Nomination Form
Anadromous Waters Catalog

Anadromous Waters Catalog Number of Water Body 212-20-10080-2605 (-3085)

Name of Water Body Slana River, *Beavis Creek ☒ USGS Name ☒ Local Name

Nomination # <u>24-932</u>	<u>Adam Reim</u> Fisheries Scientist Date <u>12-27-2024</u>
Revision Year: <u>2025</u>	<u>Ron Benfey</u> Habitat Operations Manager Date <u>12/10/2024</u>
Revision to: ☒ Atlas ☒ Catalog	<u>Charles Cathcart</u> AWC Project Biologist Date <u>27 Nov 2024</u>
Revision Code: <u>B-2, C-9, C-7</u>	<u>P. V.</u> GIS Analyst Date <u>12/30/2024</u>

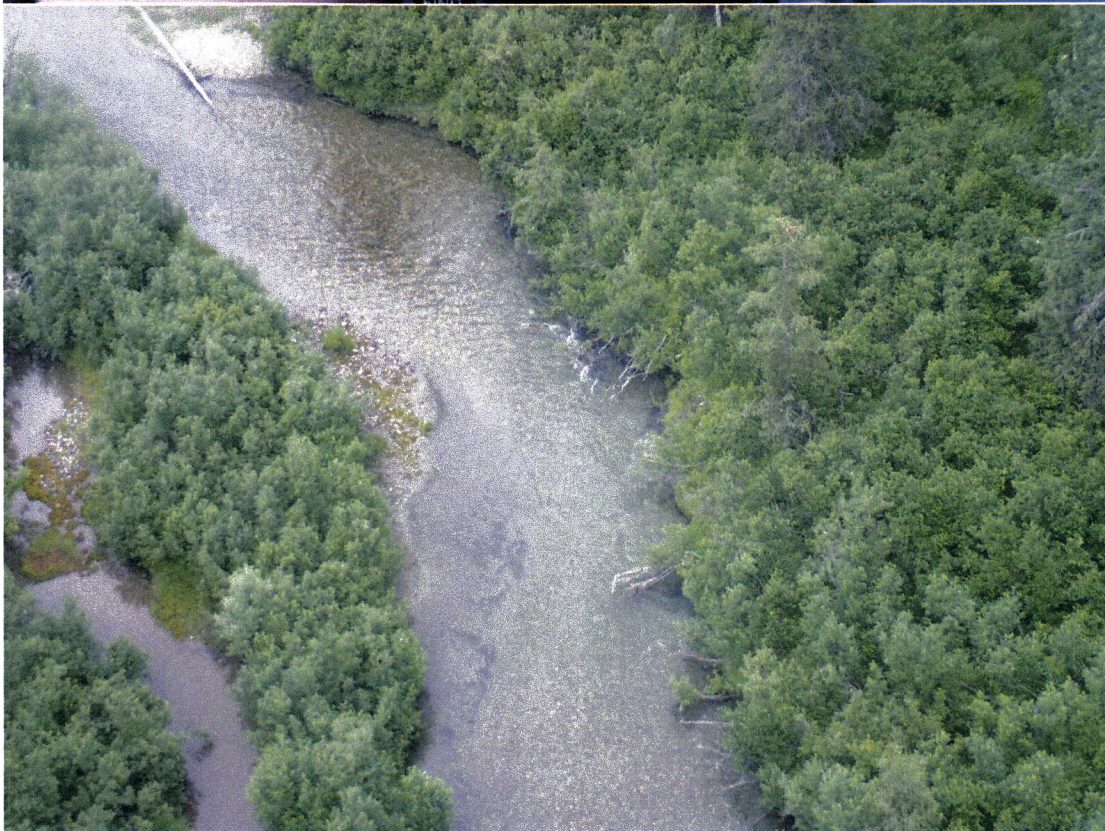
Additional Comments: Add juvenile sockeye salmon rearing to Beavis Slough at waypoint 10C03SOCKEYE (N 63.002445, W-144.194439). Two juvenile sockeye salmon were sampled with backpack electrofishing here.

Map #2

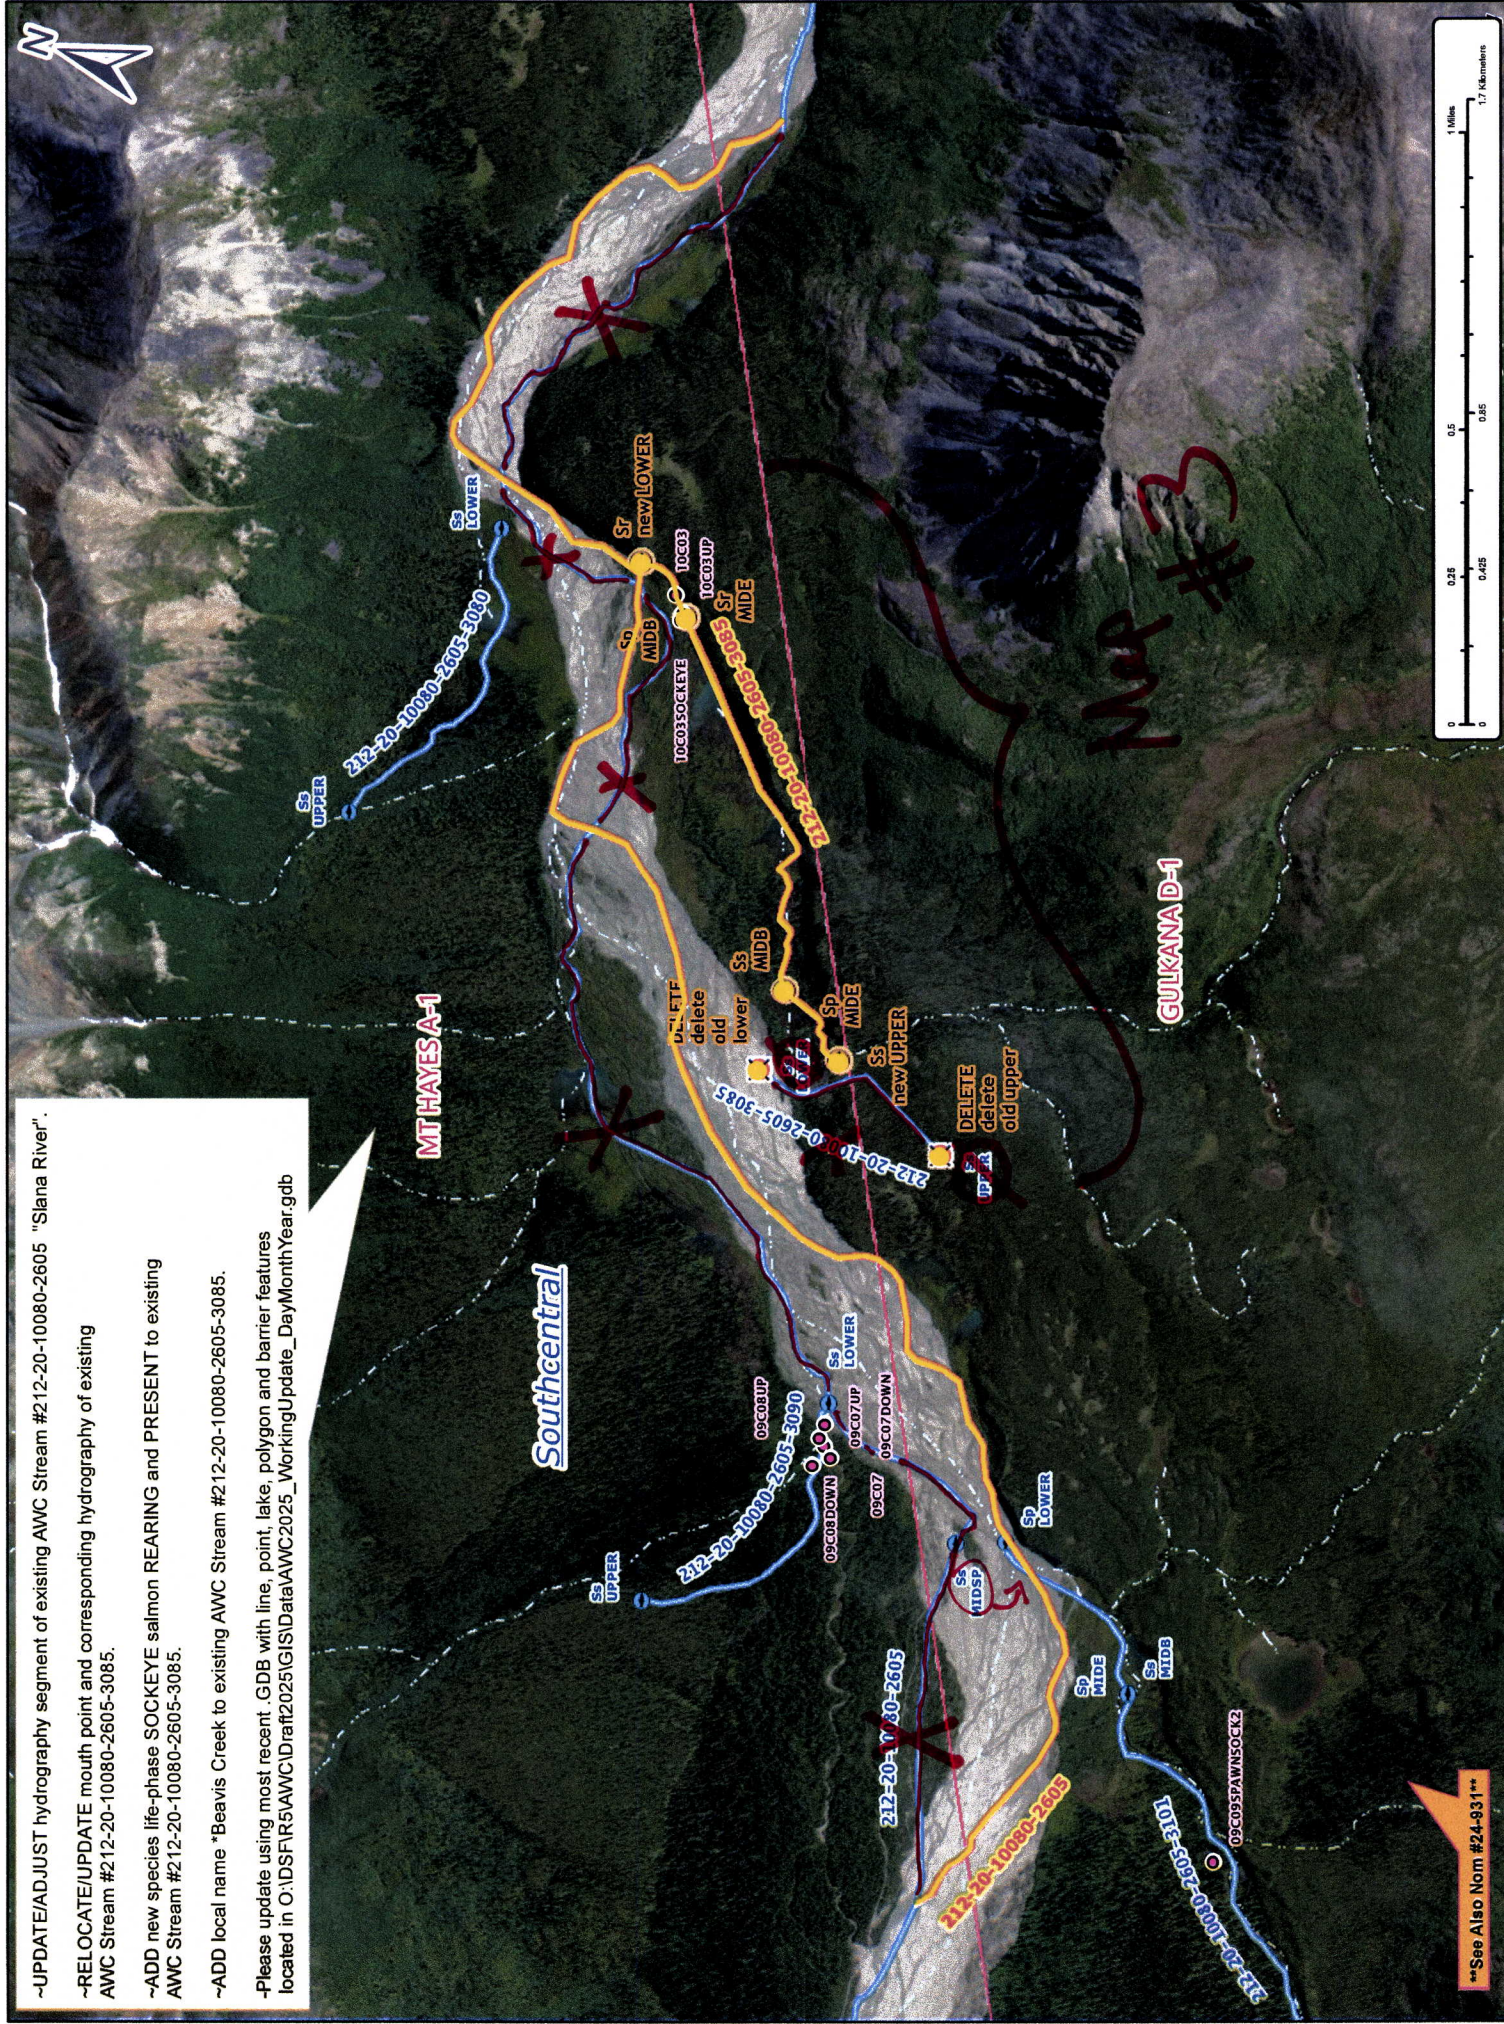
~UPDATE/ADJUST hydrography segment of existing AWC Stream #212-20-10080-2605 "Slana River".

~RELOCATE/UPDATE mouth point and corresponding hydrography of existing

AWC Stream #212-20-10080-2605-3085.

~ADD new species life-phase SOCKEYE salmon REARING and PRESENT to existing AWC Stream #212-20-10080-2605-3085.

~ADD local name *Beavis Creek to existing AWC Stream #212-20-10080-2605-3085.
